## Staff Summary Report

**SUBJECT:** Hold a public meeting for a Development Plan Review for UNIVERSITY CENTER III located at 1240 E. University Drive.

**COMMENTS:** Request for **UNIVERSITY CENTER III (PL070127)** consists of a three-story 120,000 square foot office building on approximately 7.16 net acres, in the GID, General Industrial Zoning District, within the Rio Salado and Transportation Overlay Districts. The request includes the following:

**DPR07070** – Development Plan Review including site plan, building elevations, and landscape plan.

### SITE PLAN

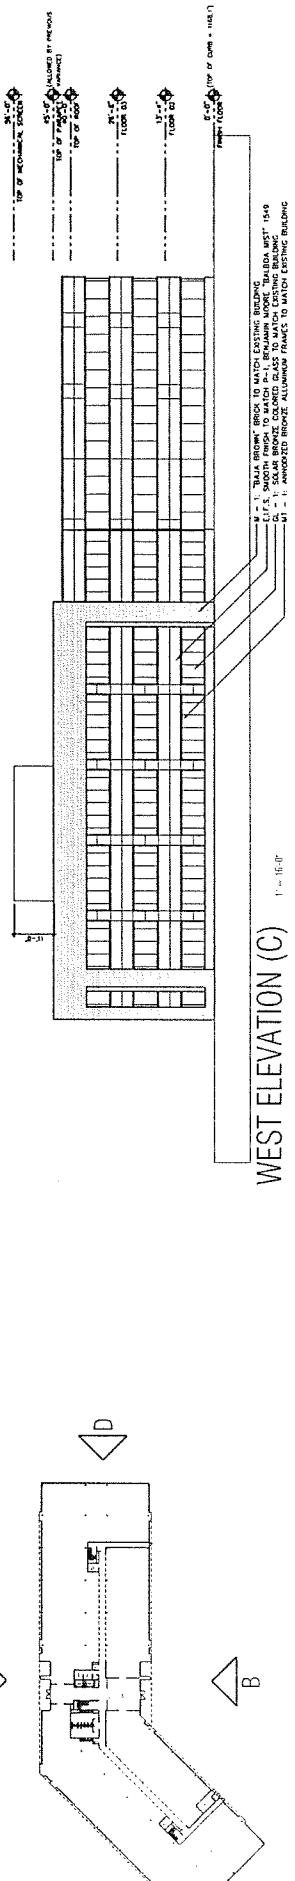
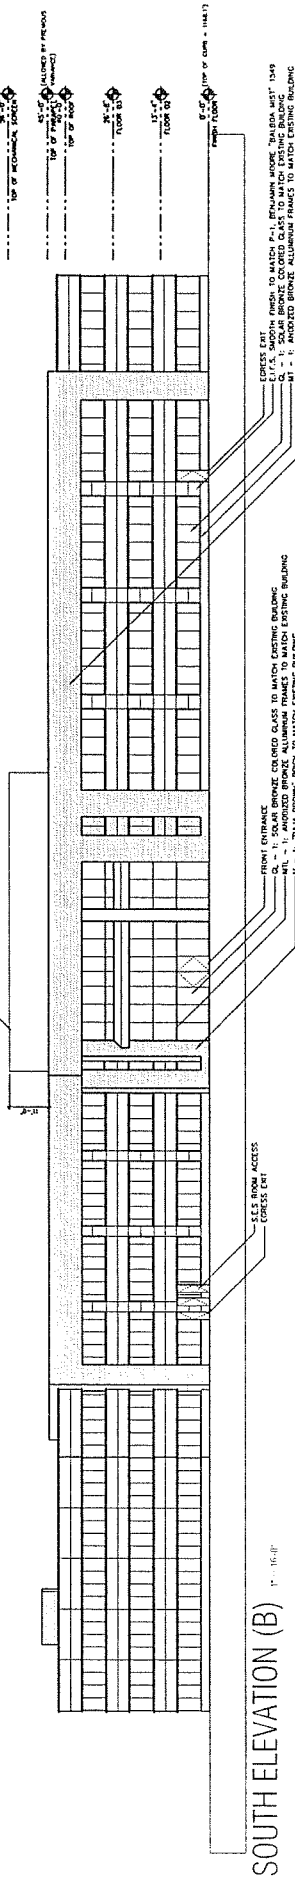
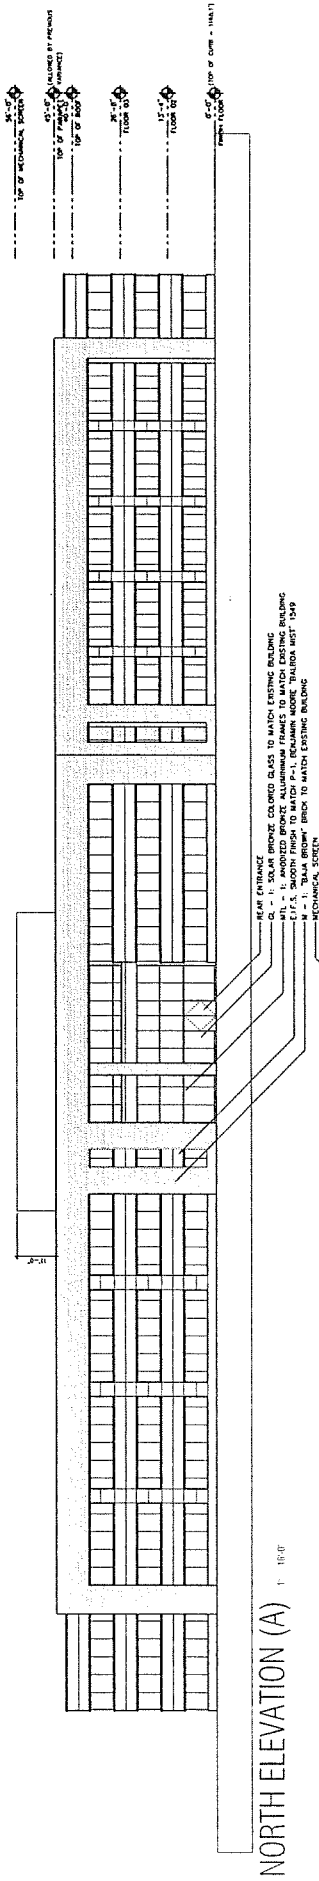
- Why not have office adjacent to University and Dorsey as stipulated by the T.O.D.? If the T.O.D. stipulations are not met, is this not setting the wrong precedent? (Administrative Decision made by Planner Director that the project meets the intent of the T.O.D.--letter to Stephan Earl from Lisa Collins, dated 8/1/06)

- Can parking quantity be reduced? (NO—Quantity is a programmatic requirement of the office. Applicant has an approved use permit to allow parking in excess of 125% of what is required. Applicant has added additional trees in parking lot in conjunction with the use permit request.

- The site layout with parking in front of building is not preferred. Commission is not opposed to main building where it is proposed but would prefer to see secondary buildings lining University and Dorsey and parking concealed in the interior of the site. If no building is required out front as indicated by the Administrative Decision, provide an increased landscape buffer. Have the buffer include the area of the south parking row. Provide a berm in the buffer along University in conjunction with the parking screen wall.

- Commission would like to see an exterior employee break patio should be added.
- Commission agrees the use is appropriate.
- Commission abstains from voting whether the project furthers goals of Rio Salado Overlay District since the project is remote from the town lake.

3. Provide service yard and mechanical yard walls that are at least 8'-0" tall as measured from adjacent grade and are at least the height of the equipment being enclosed, whichever is greater. Verify height of equipment and mounting base to ensure that wall height is adequate to fully screen the equipment. Locate electrical service entrance sections inside the service yard, as indicated.

4. Refuse:
    - a. Double container enclosure indicated on site plan is exclusively for refuse. Construct walls, pad and bollards in conformance with Standard Detail DS-116.

- b. Location of double container enclosure in west vehicle court has changed since the March 24, 2006 Site Plan Review. Contact Sanitation staff (Ron Lopinski 480-350-8132) to verify that vehicle maneuvering and access to the enclosure is still adequate.

8. Provide a shaded outdoor employee break area near the building.
  9. Provide a landscaped buffer, including a berm along University in conjunction with the parking screen wall.

- Parking spaces:
  - Verify conformance of accessible vehicle parking to the Americans with Disabilities Act of 1990 (42 U.S.C.A. §12101 ET SEQ.) and the Code of Federal Regulations Implementing the Act (28 C.F.R., Part 36, Appendix A, Sections 4.1 and 4.6). Refer to Standard Detail T-360 for parking layout and accessible parking signs. Consider location of west lobby entrance with respect to layout of disabled accessible parking; the layout as indicated exclusively favors the east lobby entrance.

ELEVATIONS

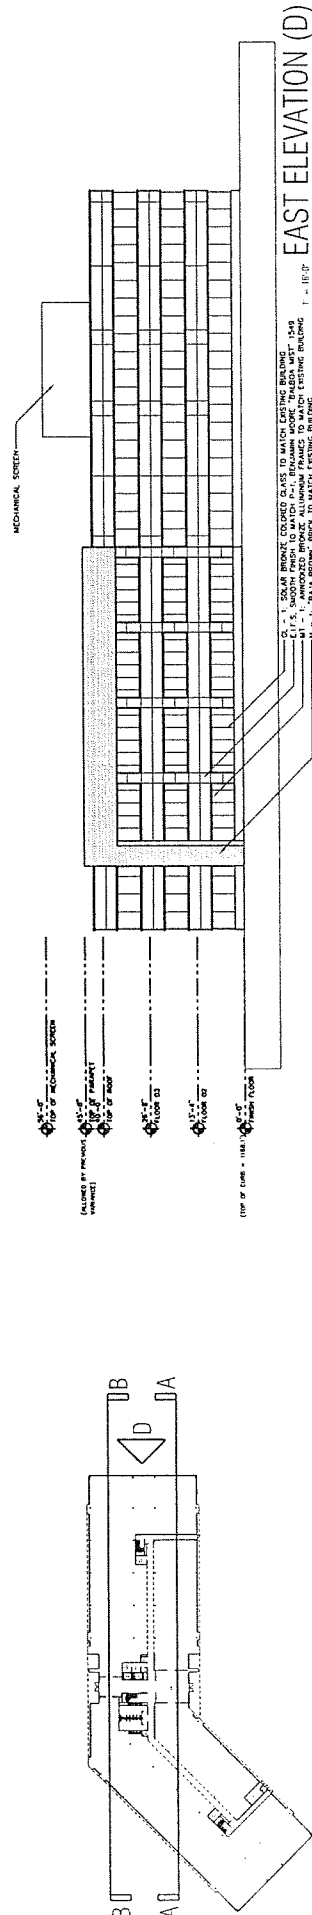
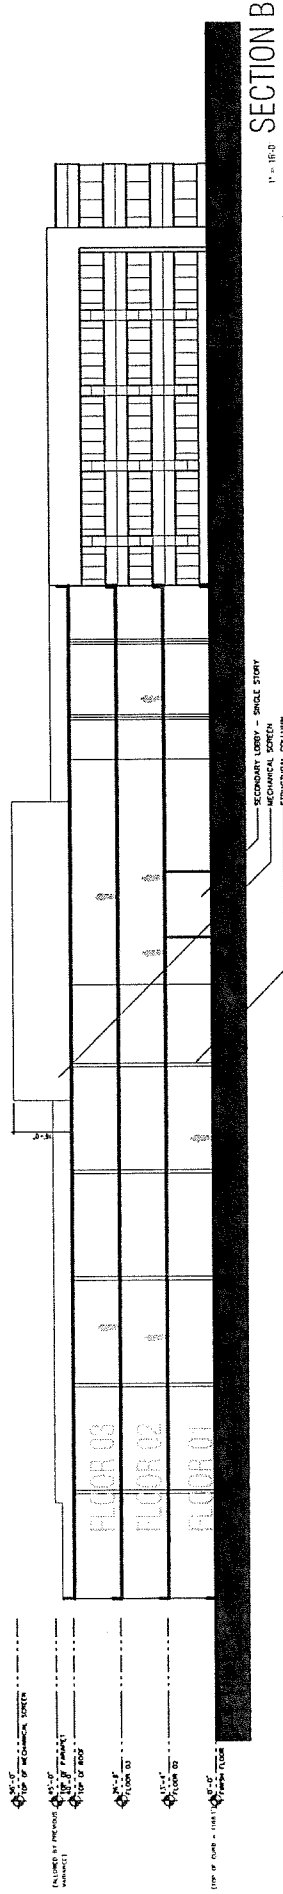
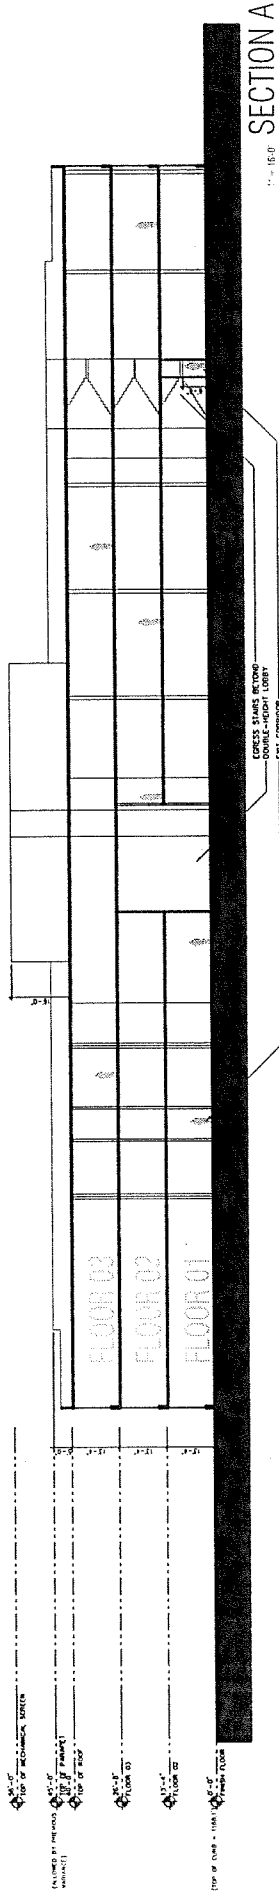
14. Provide main colors and materials with a light reflectance value of 75 percent or less. Specific colors and materials exhibited on the materials sample board are approved by planning staff. Submit any additions or modifications for review during building plan check process. Planning inspection staff will field verify colors and materials during the construction phase.

15. Provide secure roof access from the interior of the office building. Do not expose roof access to public view.
  16. Conceal roof drainage system within the interior of the building. Minimize visible, external features, such as overflows, and where needed design these to enhance the architecture of the building.

17. Incorporate lighting, address signs, incidental equipment attachments (alarm klaxons, security cameras, etc.) where exposed into the design of the building elevations so that the architecture is enhanced by these elements.

18. Locate the electrical service entrance section (S.E.S.) inside the building.
  19. Exposed conduit, piping, etc. is not allowed unless a creative conduit surface design that compliments the architecture is reviewed and approved by planning staff.

24. Provide one address sign on each building elevation, horizontally near either end of the elevation and vertically between the second floor level windows and the top of the building. Additionally place one address sign centered on the south elevation, over the main entrance. Match the height of all address signs.
